## 5 Government submissions

This chapter provides a summary and response to the eight local and State government submissions (including interagencies) received on the proposed modification.

### 5.2 Department of Planning and Environment

**Figure 5.14** Graphical analysis of meteorological conditions at Scone Airport AWS (2014 vs all other data)

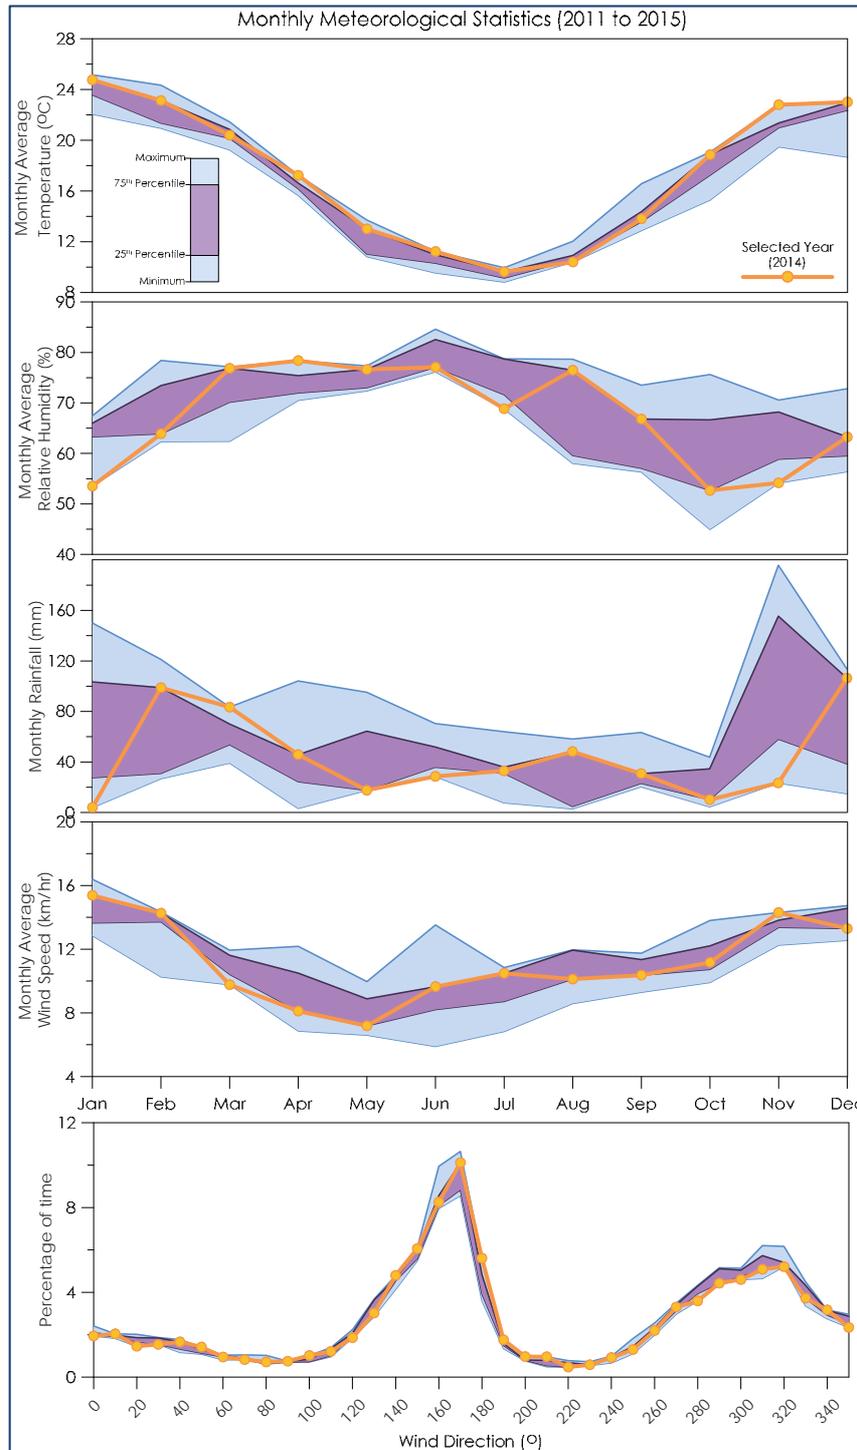
The EPA requested that analysis demonstrating why calendar year 2014 is an appropriately representative year for dispersion modelling by comparison to at least five years of contiguous and recent data.

Figure 5.14 also shows the monthly maximum, minimum, 25<sup>th</sup> and 75<sup>th</sup> percentile values for the recorded monthly data in each year for the various meteorological parameters.

The data for 2014 is presented as the orange line on Figure 5.14 for comparison with the longer term data set trends shown in the blue colours. The figure indicates that 2014 typically has values within the 25<sup>th</sup> and 75<sup>th</sup> percentiles of the overall data.

**Figure 5.18** Predicted annual average PM<sub>2.5</sub> concentrations due to emissions from the proposed modification and other sources in Stage 2 ( $\mu\text{g}/\text{m}^3$ )

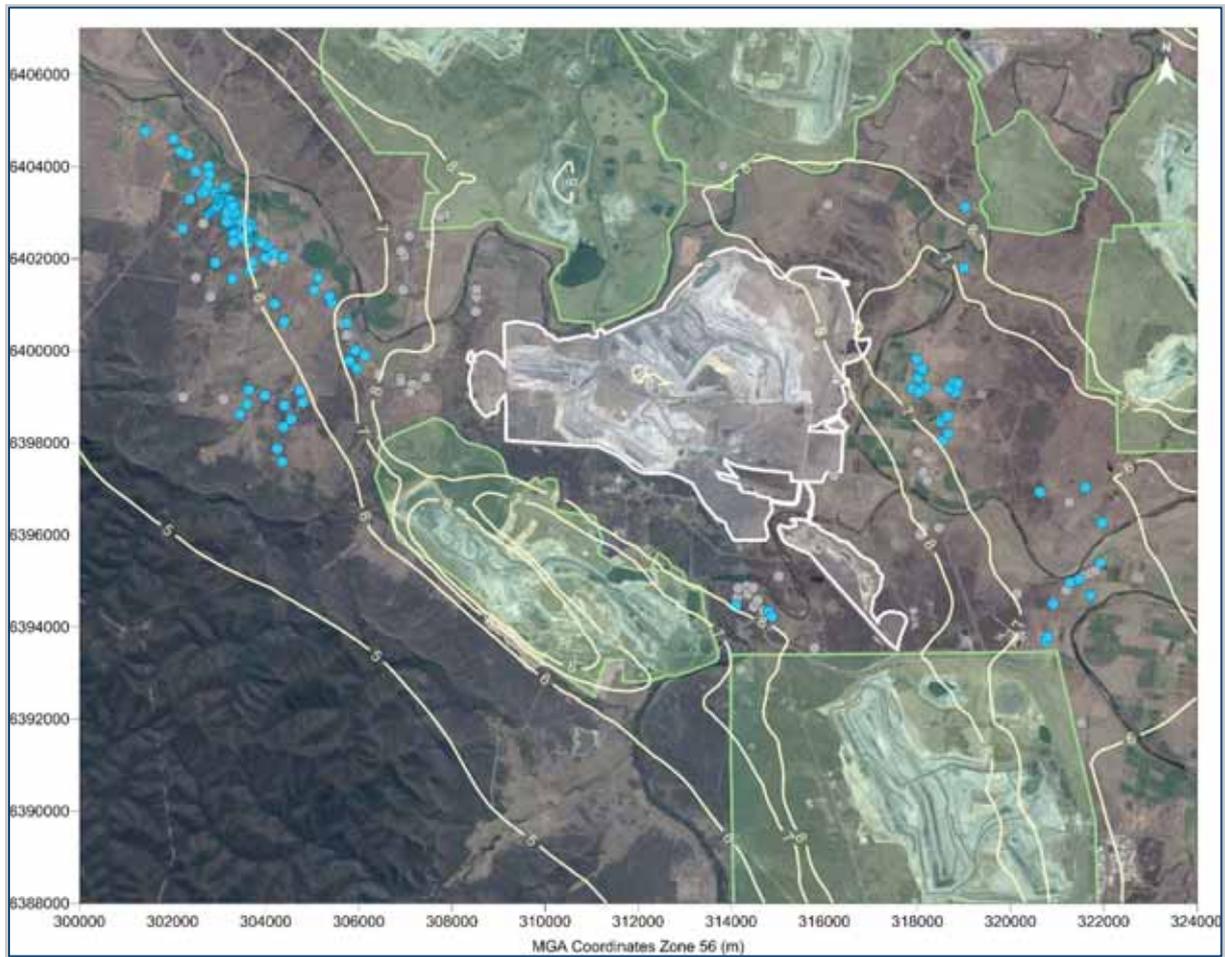
Hunter New England Population Health branch of the NSW Department of Health requested that the 7µg/m<sup>3</sup> contour for annual average PM<sub>2.5</sub> for Stage 2 and 3 be presented.

Figures 5.18 and 5.19 show isopleths including the 7µg/m<sup>3</sup> value for the predicted annual average PM<sub>2.5</sub> concentrations due to the proposed modification and other sources during the most active stages of the mining nearest residences, Stage 2 and Stage 3, respectively.
